CASE SUMMARY SHEET**CASE NUMBER: V23-10-36****DATE RECEIVED: September 20, 2023****DATE OF MEETING: October 24, 2023 and November 14, 2023****Address: 233 Marigny****Subdivision: Old Town of Mandeville, Square 8 Lots 15 & 16****Zoning District: R-1 Single Family Residential District****Property Owner: John Cerniglia****REQUEST: V23-10-36 – John Cerniglia requests a variance to CLURO Section 5.2.3.2. Drainage Overlay District and Fill Sub-Area A, Old Town of Mandeville, Square 8 Lots 15 & 16, R-1 Single Family Residential District, 233 Marigny Avenue****CASE SUMMARY:**

CASE SUMMARY SHEET**CASE NUMBER: V23-11-37****DATE RECEIVED: September 18, 2023****DATE OF MEETING: November 14, 2023 and December 12, 2023****Address: 245 Marigny****Subdivision: Old Town of Mandeville, Square 8 Lot 14****Zoning District: R-1 Single Family Residential District****Property Owner: Jim and Marison Tucker**

DRAINAGE PLAN

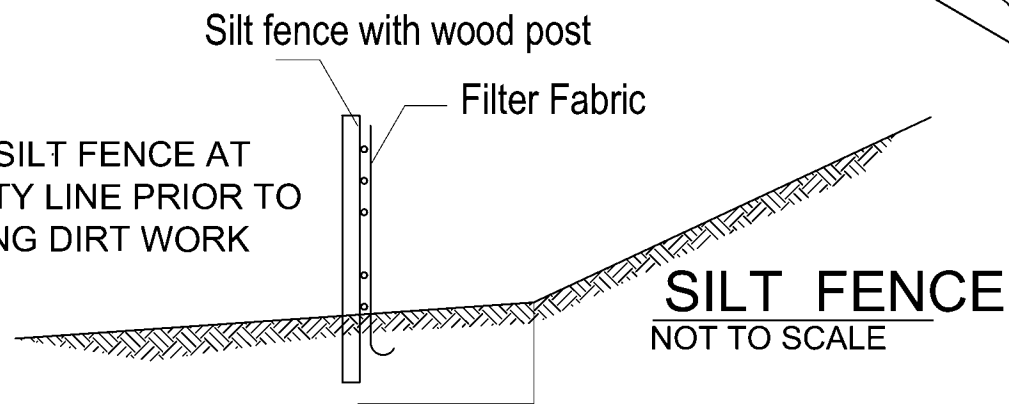
Public works has reviewed the submitted drainage plan and had the following comments. The maximum height allowed by CLURO Sec 5.2.3.2 for the ground level slab would be 6.52. The additional height is minimal and would not have impacts on neighboring properties. The proposed drainage plan would be acceptable if the height variance is granted.
